Application for Licence Amendment

| Licence Number | L6818/1997/11 |
| Licence Holder | Shire of Bridgetown Greenbushes |
| Premises | <p>Bridgetown Waste Management Facility</p> <p>Lot 903 Bridgetown – Boyaup Brook Road</p> <p>BRIDGETOWN WA 6255</p> <p>Legal description –</p> <p>Lot 903 on Plan 189961</p> |

Figure 1: Current liquid waste facility freeboard assessment

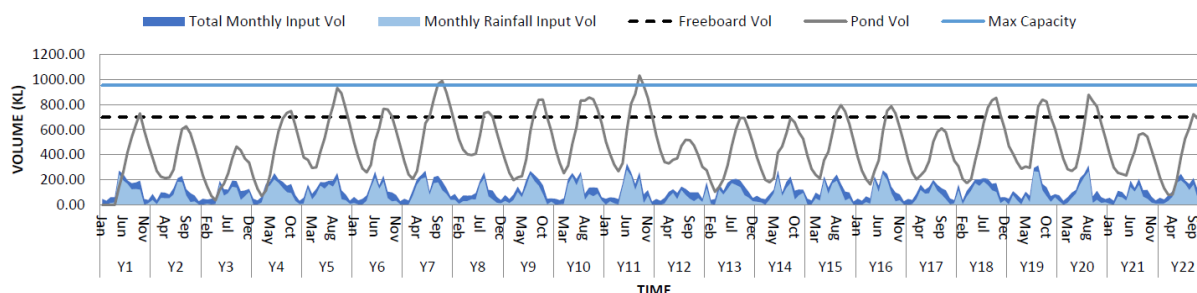
The review undertaken by the Licence Holder shows that freeboard was being breached 15 years out of the 22 years that were modelled and with a potential pond overflow event 3 out of 22 years. The Licence Holder confirms that the result of the modelling is supported by actual performance of the facility. Since commissioning, the facility has not been able to accept

waste during winter and spring due to high levels in the liquid waste facultative pond.

The Licence Holder noted that the freeboard issues identified are only occurring during the winter period when evaporation is low, but liquid waste input is at a maximum due to rainfall. During the summer months the volume of the pond drops significantly, indicating there is a large evaporation surplus during this period. Evaporation data recorded from Bridgetown showed that average evaporation for the 20 year modelling period is 1,325 mm (based on daily evaporation from 2000 to 2022). The total monthly evaporation ranged between 36.8 mm in June 2010 and 262.7 mm in January 2021. The total average evaporation exceeds average annual rainfall by approximately 582 mm, with rainfall generally exceeding evaporation between May to September.

Figure 2: liquid waste facility freeboard assessment, with storage tanks

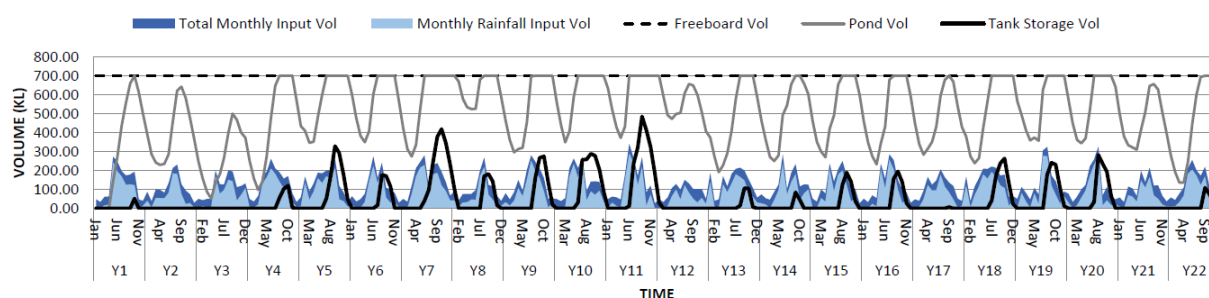
The applicant's proposed design is to incorporate two 250,000 L liquid waste storage tanks (500,000 L total storage capacity) to maintain liquid waste pond freeboard within the allowed 300 mm freeboard requirement of the licence. The required storage volume was calculated by assessing the liquid waste inputs and total rainfall for the past 22 years against the total storage capacity of the liquid waste pond. It can be seen in the below Figure 2, that a total of 500,000 L will be sufficient to maintain freeboard of the liquid waste pond through the winter periods, whilst being capable of emptying the liquid waste storage ponds and evaporating the liquid waste during the summer period.

During winter, the Licence Holder proposes to pump liquid waste from the facultative liquid waste pond to the liquid waste holding tanks as required to maintain 300mm freeboard via continuous (no joints) above ground pipe. The pump is proposed to be positioned within the bunded area so that any leaks or spills will be contained within the bunded area and returned to the facultative pond via the drainage sump. The applicant has proposed to return liquid waste to the facultative pond during the summer period via gravity feed into the sump within the bunded area.

Figure 3: Proposed liquid waste management infrastructure

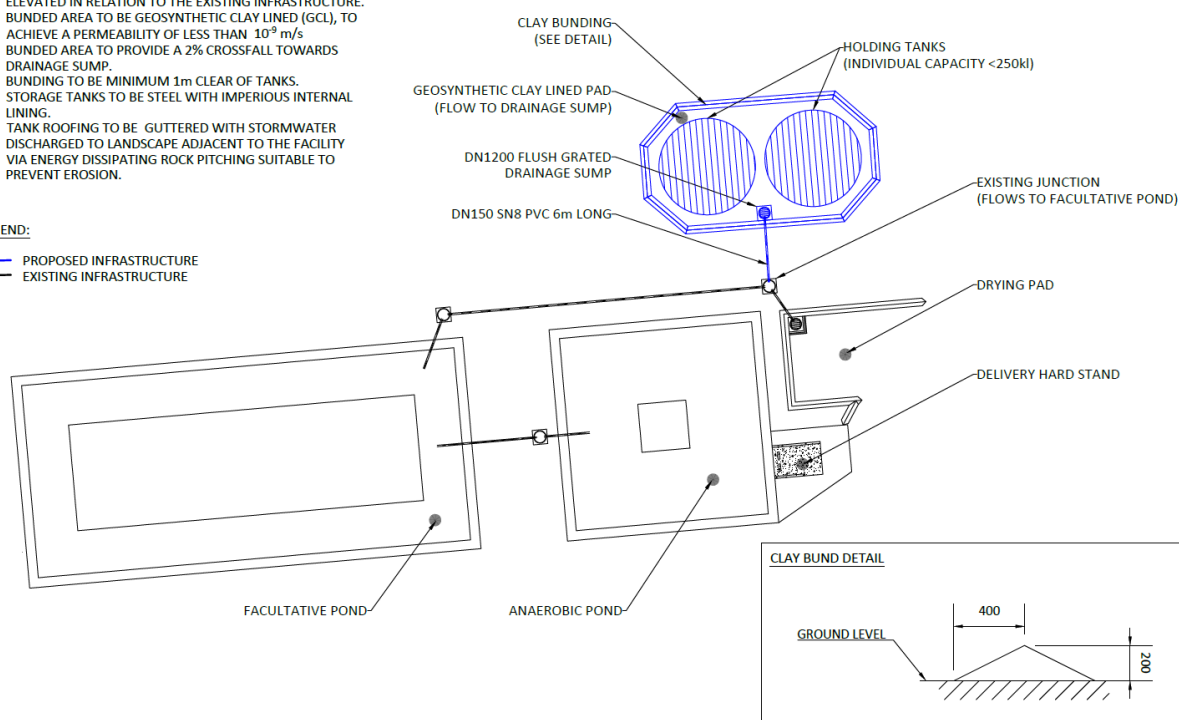
Key findings: The Delegated Officer has reviewed the proposed design of the liquid waste holding tanks proposed by the Licence Holder and considers the following:

1. DWER does not consider the proposed construction meets the definition of secondary containment infrastructure. Secondary containment refers to any means used to contain liquid leaks or spills if the primary storage container or transfer mechanism fails. Secondary containment areas prevent liquids from escaping to the environment. The use of the facultative pond as secondary containment infrastructure may also result in the freeboard requirements of the licence not being met.
2. The discharge of the liquid waste to the bund floor prior to being transferred to the facultative pond will result in erosion and impact the integrity of the geosynthetic clay liner.
3. Additional infrastructure and design requirements for the liquid waste holding tanks and secondary containment infrastructure will be considered as part of the risk assessment.

| Condition | Summary of Licence Holder's comment | Department's response |
|--------------------------|--|---|
| Condition 31 Table 13 | The licence holder wishes to amend the construction of the tank pad. The newly proposed design is to construct a 25mm asphalt tank pad with a waterproof surface coating applied to the asphalt. The tank pad will be constructed on top of a 200mm compacted gravel subgrade. | The Delegated Officer deems the proposed construction is adequate and does not alter the risk assessment undertaken for the construction and operation of the liquid waste holding tanks. The condition has been updated. |
